CITY OF West Linn

STAFF REPORT FOR THE PLANNING COMMISSION

FILE NUMBER: SUB-15-01

REQUEST: 22-lot Subdivision at 22850 and 22848 Weatherhill Road

31 JOB ID # 11011
LAND USE # 1
TAX LOT # 5
DESIGNED BY TGH
CHECKED BY TGH
SITE PLAN
SHEET NUMBER
C2.1

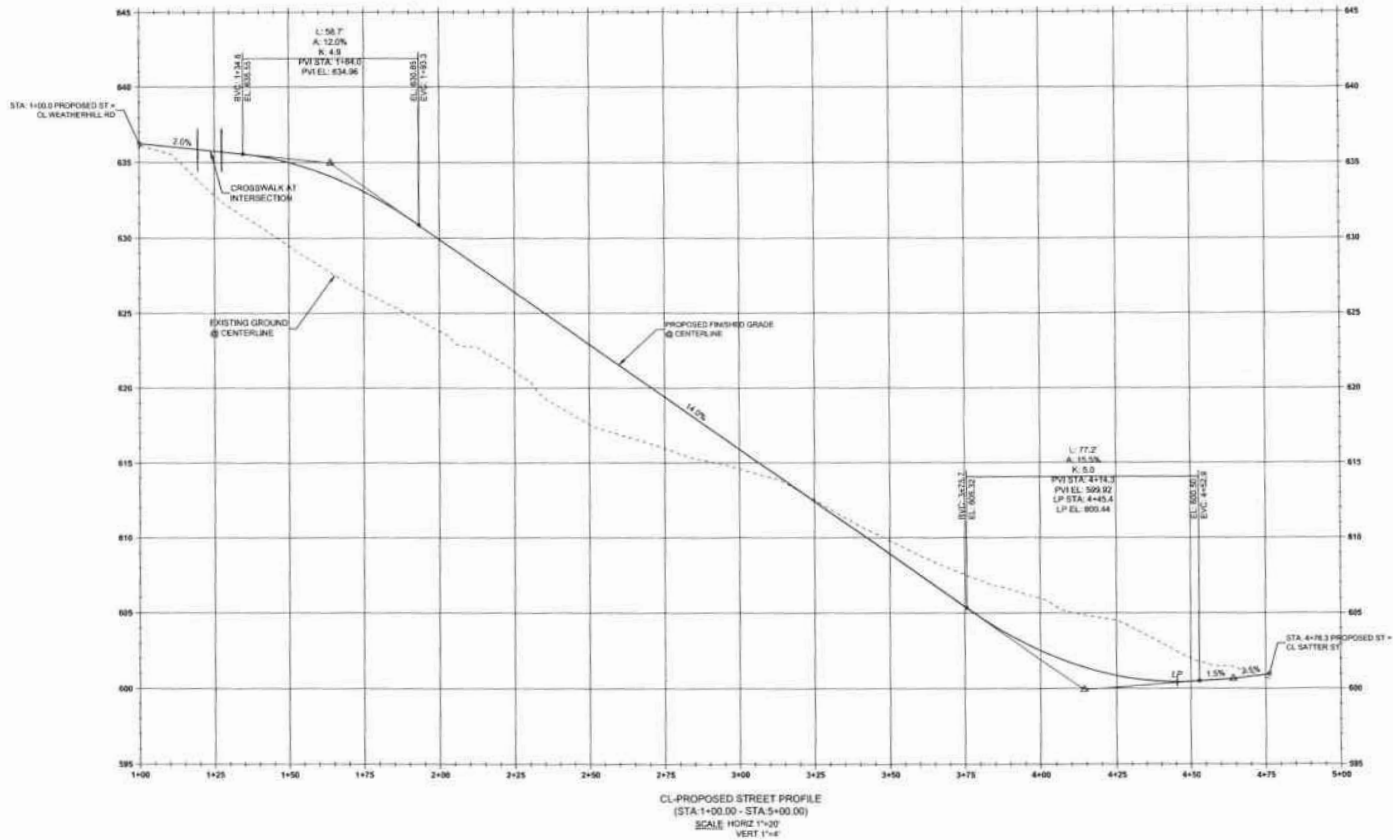
Applicant's Finding: The Applicant has revised the Site Plan (Sheet C2.1) to show the zoning on and adjacent to the subject property.

Applicant's Finding: The Applicant has revised the Site Plan (Sheet C2.1) to show the existing houses on adjacent properties.

GRADING AND EROSION CONTROL PLAN
WEATHERHILL ESTATES
SUBDIVISION
WEST LINN, OR
BLACK DIAMOND PROPERTIES, LLC

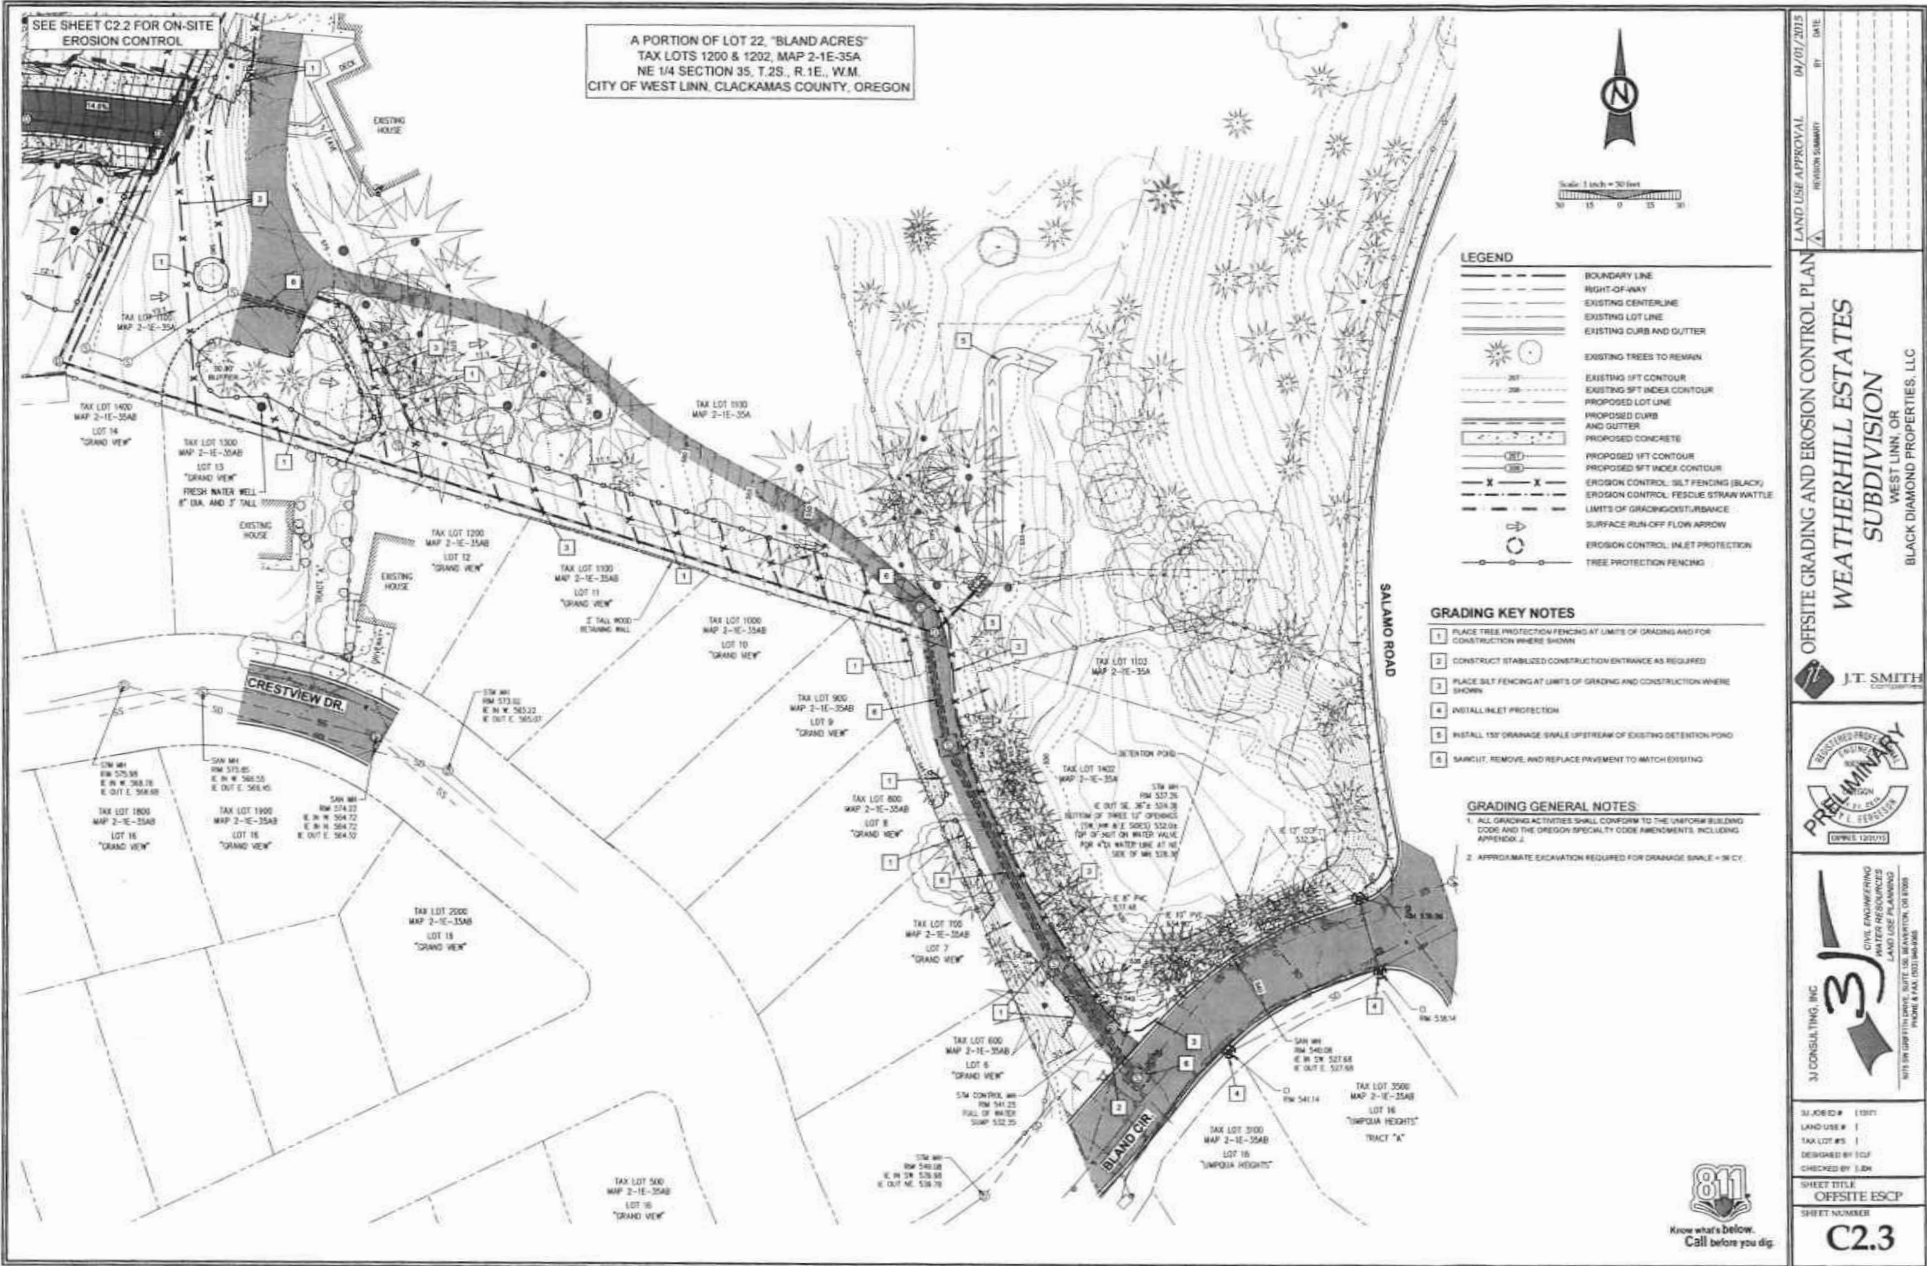
Protection for trees, shown on applicant's "Grading and Erosion Control Plan map" (sheet C2.2) (dated 4/1/2015), will be facilitated throughout the site grading and development process by the temporary installation of cyclone fences, per the West Linn Tree Technical Manual.
